5440 WADE PARK BLVD, SUITE 102 WWW.BGEINC.COM NC LICENSE #C-4397 ©2023	DESIGNED BY:				
	DRAWN BY:				
	REVIEWED BY:		DF		
			DF/JWM	10/02/2023	PER TOWN OF ROLESVILLE COMMENT
				08/01/2023	PER TOWN OF ROLESVILLE COMMENT
		REV	06/01/2023	INITIAL SUBMITTAL

PARKER RIDGE
82 SCHOOL STREET
ROLESVILLE / NORTH CAROLINA / 27571

CARVED STREET CT PLAN
AND PROFILE

GRANITE KNOLL CT PLAN
AND PROFILE (1 OF 2)

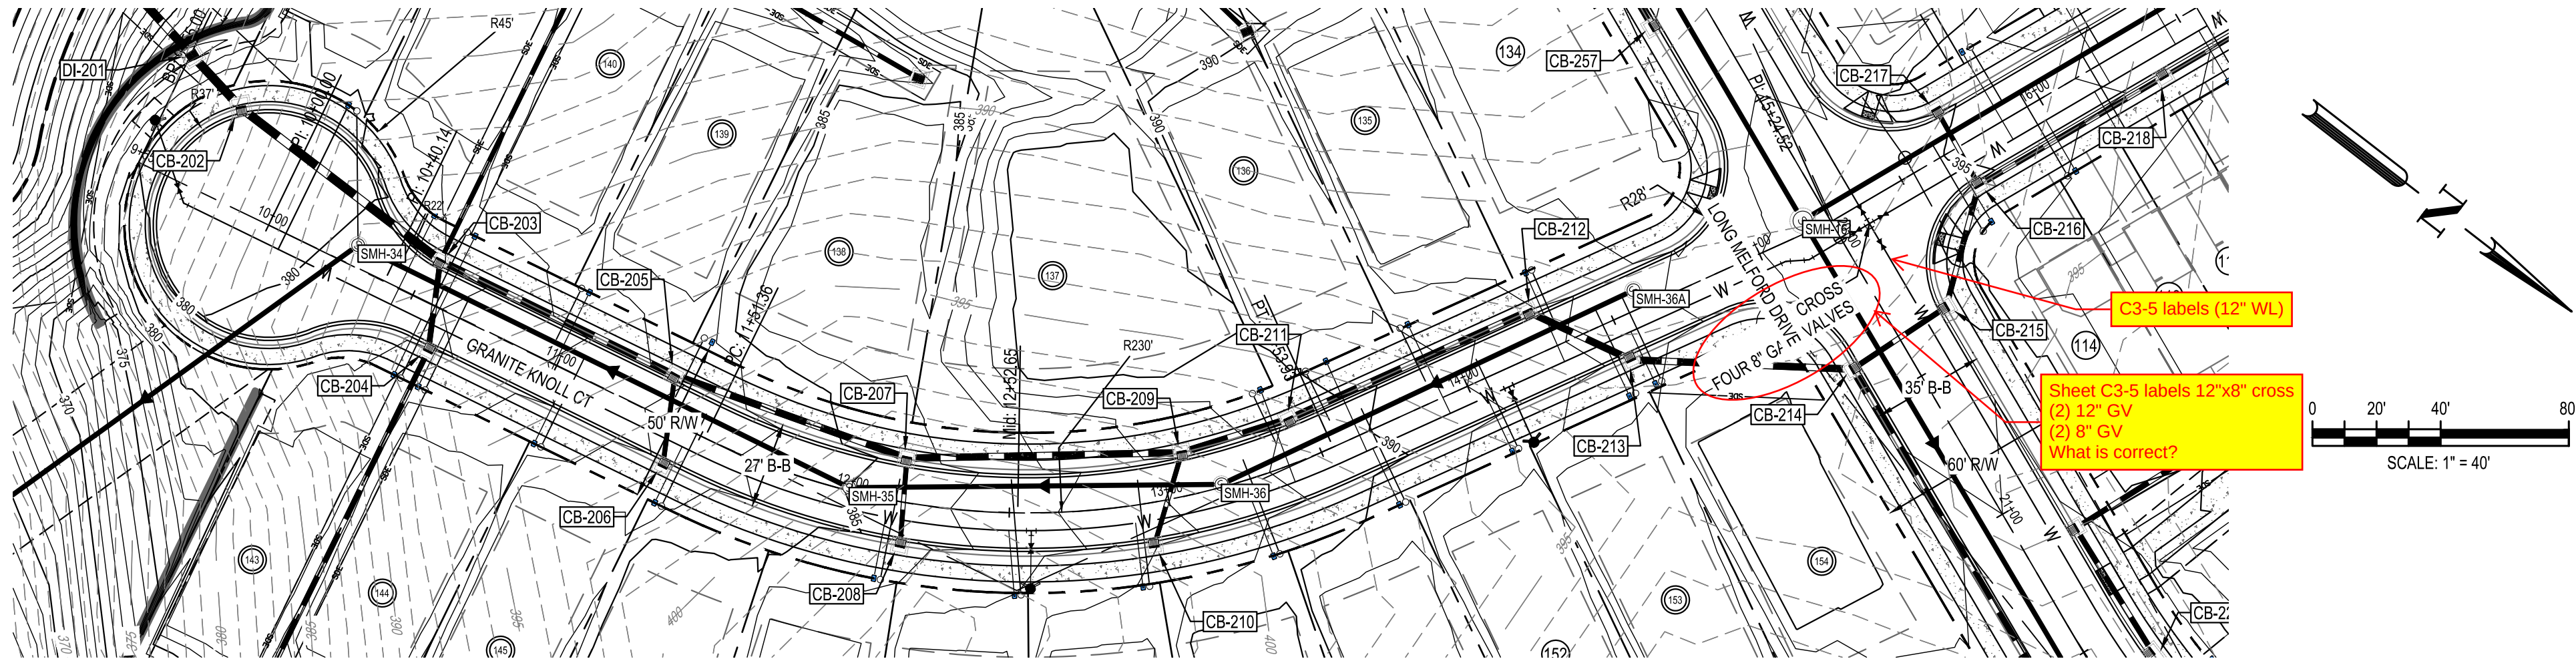
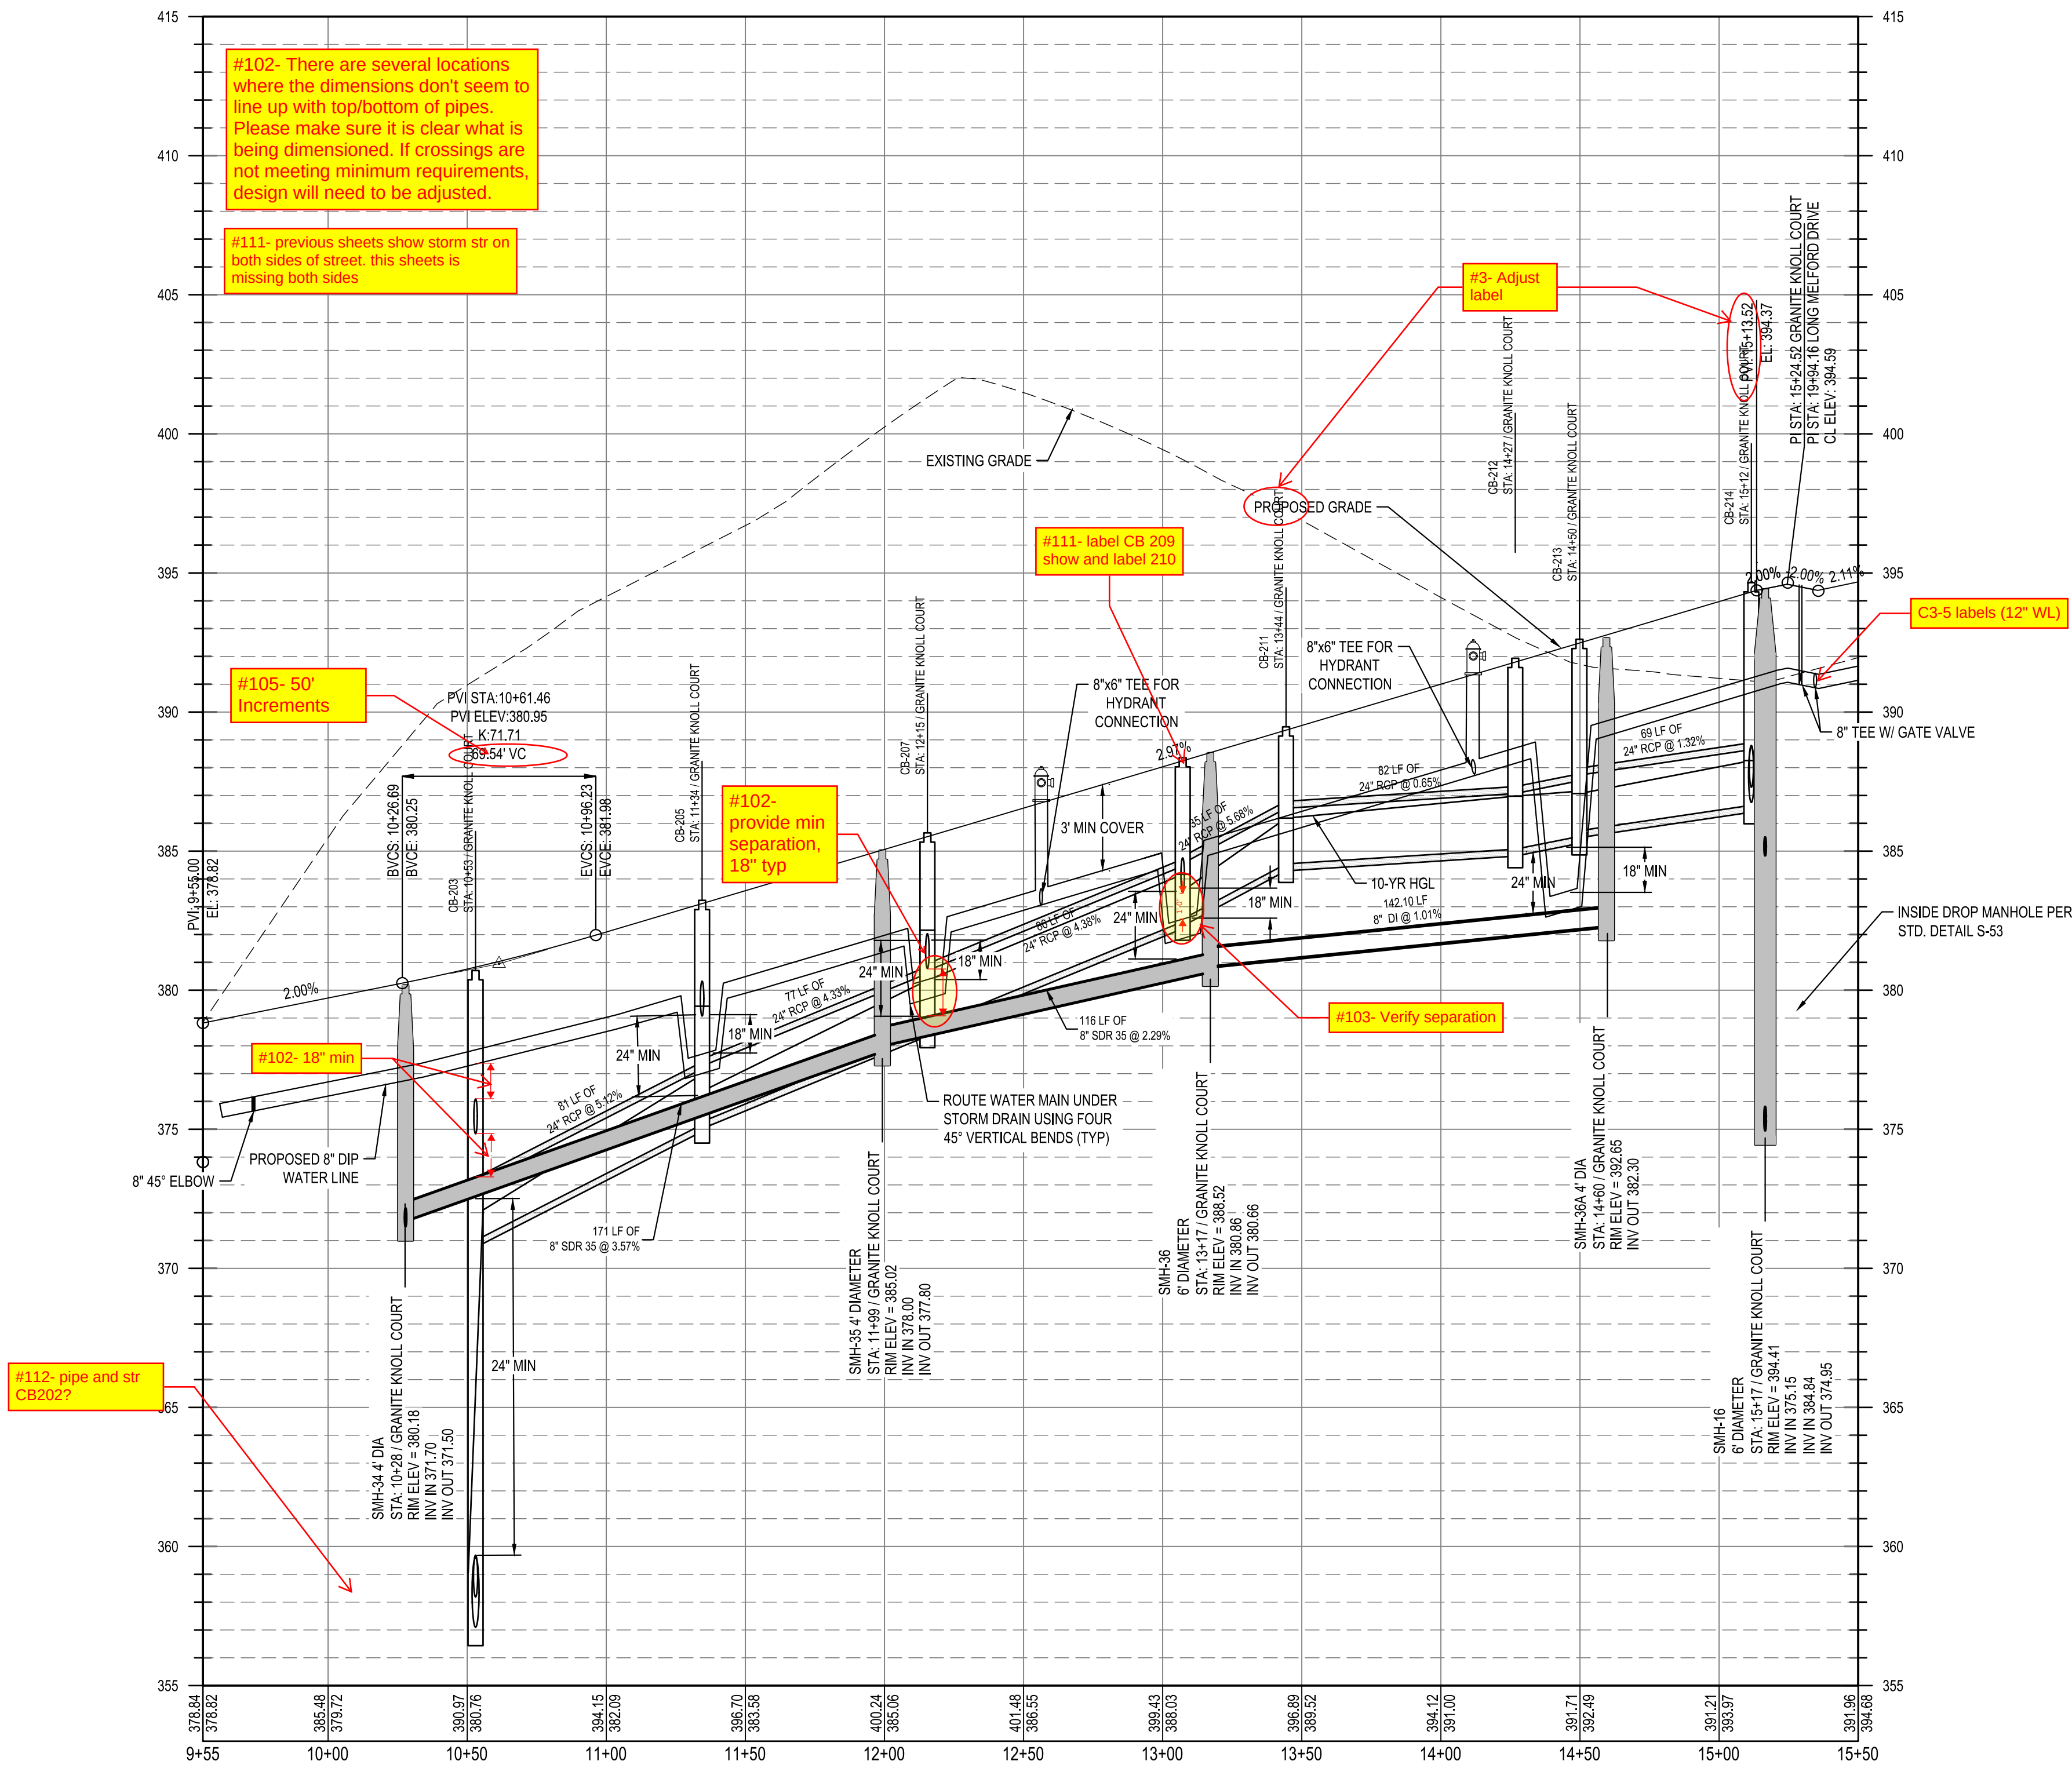
#23- There are several instances where water line, tees/crosses, and valve sizes differ between Utility plan sheets and Plan and Profile sheets. Please make the necessary adjustments to ensure that water lines, connections, and valves correct sizes remain consistent throughout all sheets.
